JADWIN DAM

DAM, OUTLET WORKS & SPILLWAY
PERIODIC INSPECTION REPORT NO. 4

NOVEMBER 1980

LACKAWAXEN RIVER BASIN
 JADWIN DAM
 DYBERRY CREEK, PENNSYLVANIA
INSTRUMENTATION PLAN

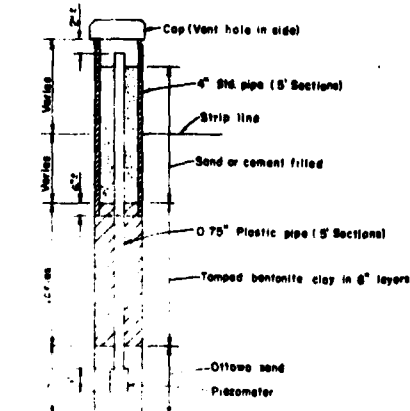
Review of piezometer data obtained prior to 1976 revealed questionable readings of piezometer DYL-19 in October and November 1974. Plate 1 has been revised to indicate the unreliability of those readings and has been included in this report for future reference.
